FINAL SITE CLOSURE REPORT

BUILDING 210 – BATTERY OPERATIONS

**CAMP NAVAJO
BELLEMONT, ARIZONA**

COMMENTS AND RESPONSES

Figure 1-2

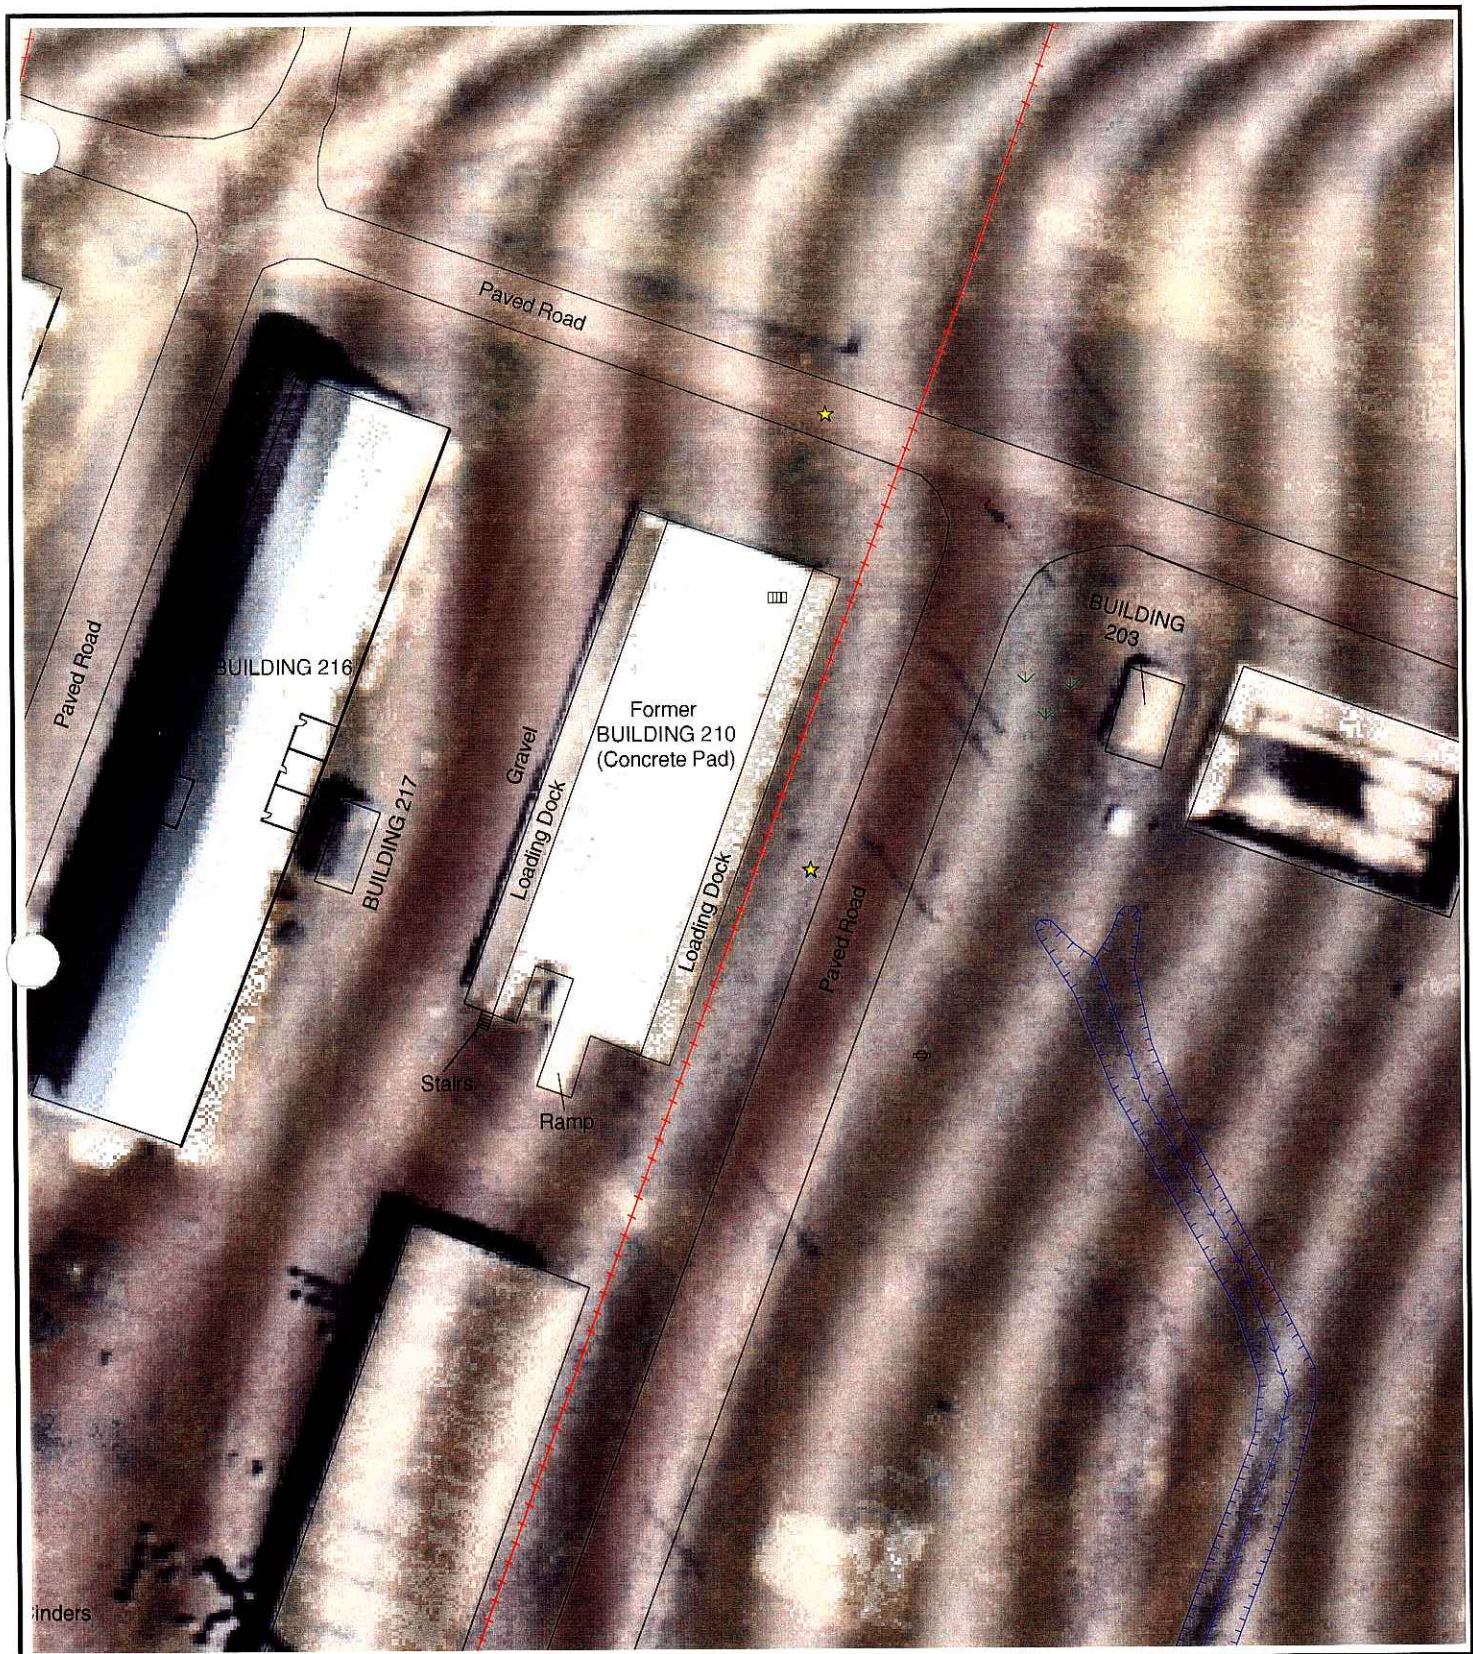
Figure 1-2 Indicate (arrow) site location	Will be revised in final.
Section 4. 5th paragraph, 5th sentence: replace crude with simple	Will be revised in final.

Figure 2-1

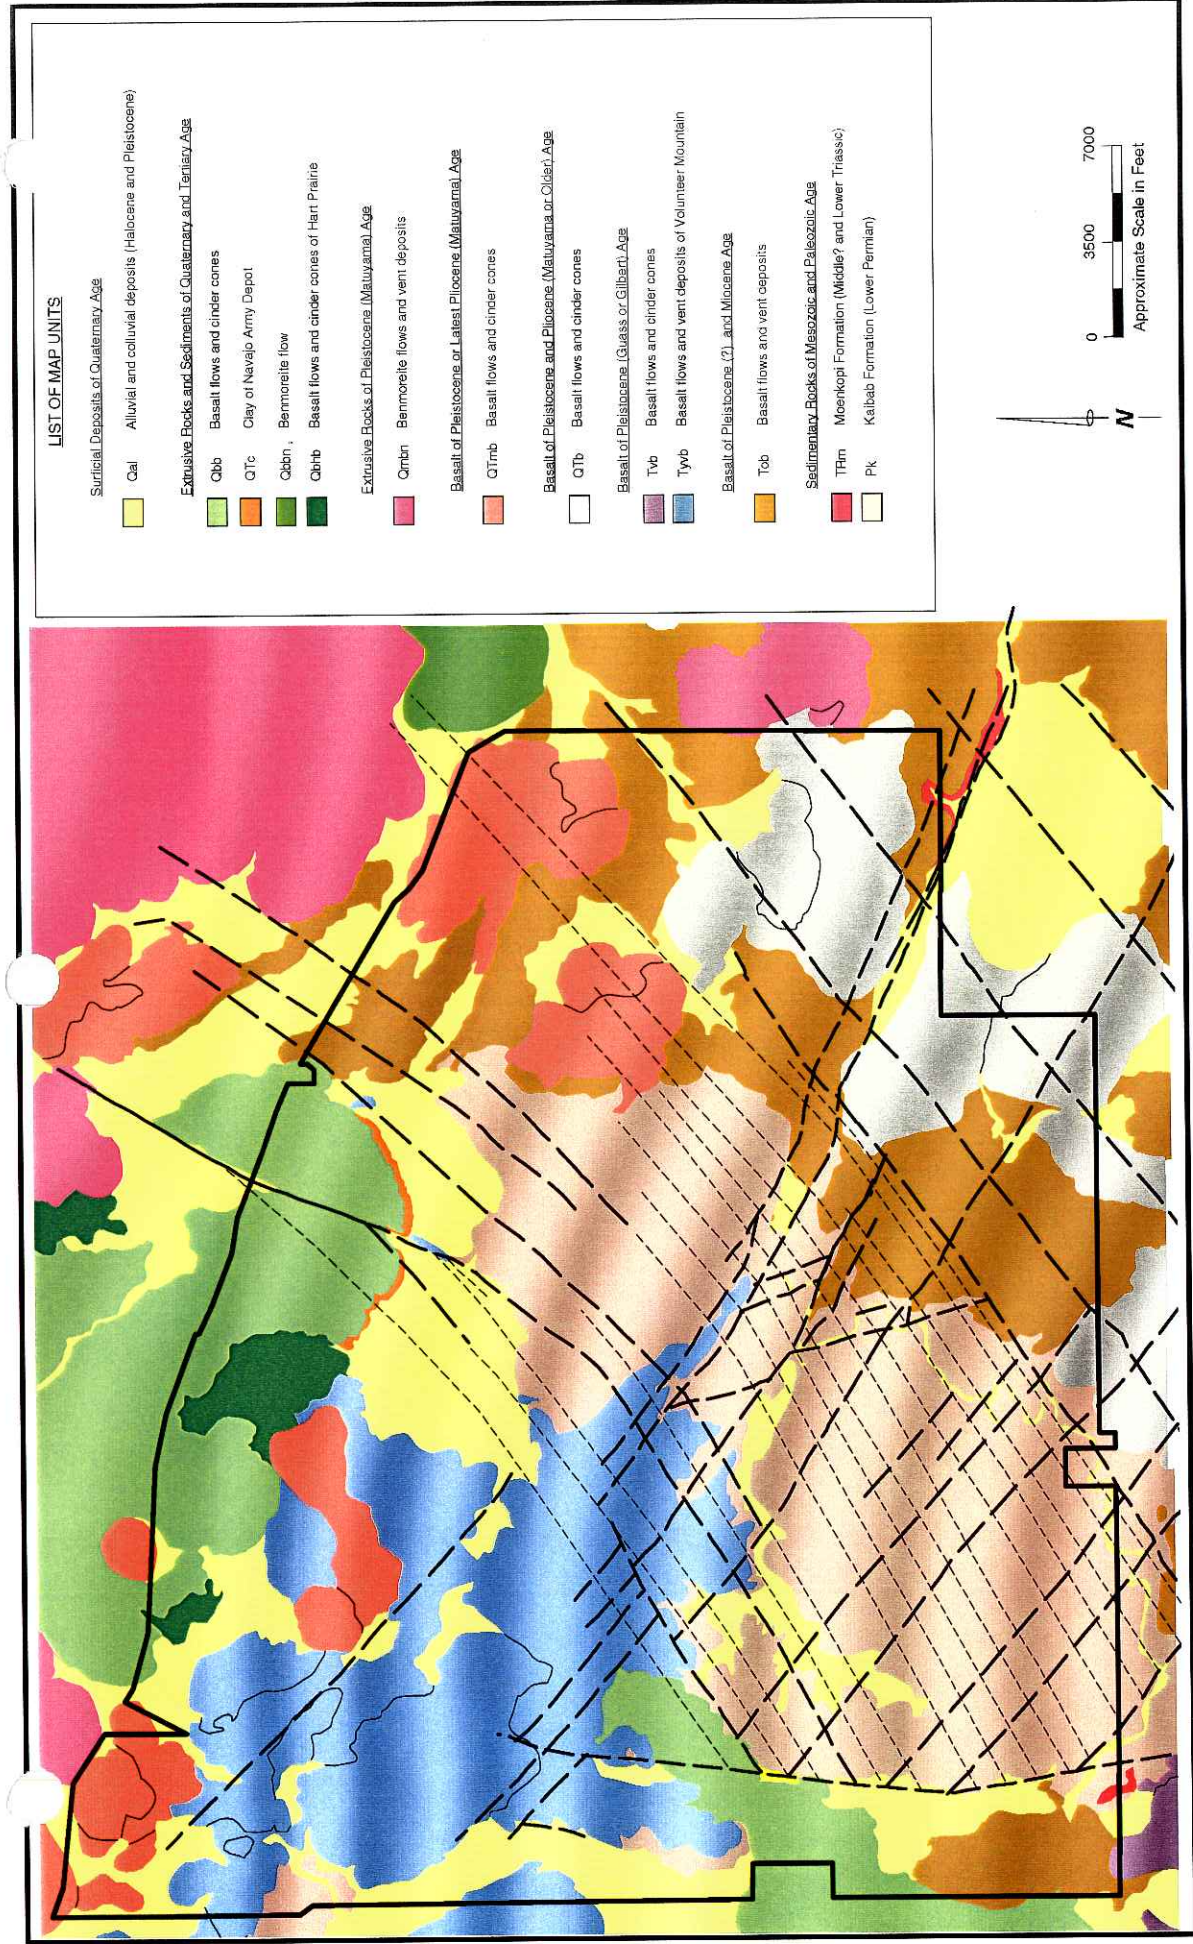
Comment	Response
Section 2. Please use the correct form of the following names; Kaibab Formation, Coconino Sandstone, San Francisco Peaks, San Francisco Volcanic field.	Text will be revised accordingly.
Section 2.2. Figure 2-1; In the older February and March reports this map has one area of alluvium along the northern boundary that is shaded as basalt. In the newer November report two more areas (along eastern boundary and along Dunham fault) are incorrectly shaded. The blatant statement regarding faults as conduits on the older maps is made palatable by the addition of "potential" on the newer version, but would probably be best if deleted entirely. Also on the November report, the legend contains incorrect symbols for the railroad and suspected fault. Personally, I liked the geologically meaningful rock symbols of the older map better than the hatchured symbols of the newer map.	Figures in all closure reports will be revised to be clear and consistent.

Comment	Response
Figure 2-1: Remove paragraph on faults as conduits	Will change text to say that a fault is a potential conduit.
Signature block: Please add Mr. Aala's title	Will be revised in final.
Appendix A: Are color photos available?	Color photos will be printed in final report.
Section 1.2. 1st paragraph, last sentence; rewrite as follows: ...for the storage of ARNG material and munitions, and the United States Air Force...	Will be revised in final and will also include US Navy.
Include reference to Uribe & Associates VSI report for USEPA/ADEQ: RCRA Facility Assessment Report, 1994, prepared for Region 9 United States Environmental Protection Agency	Will be revised in final.
Section 2.4. 1st paragraph, 1st sentence: strike approximately	Will be revised in final.
Section 1.1. Add reference to NADA and AREE numbers/designations to tie to historic documents and to regulatory listings	Will be revised in final.
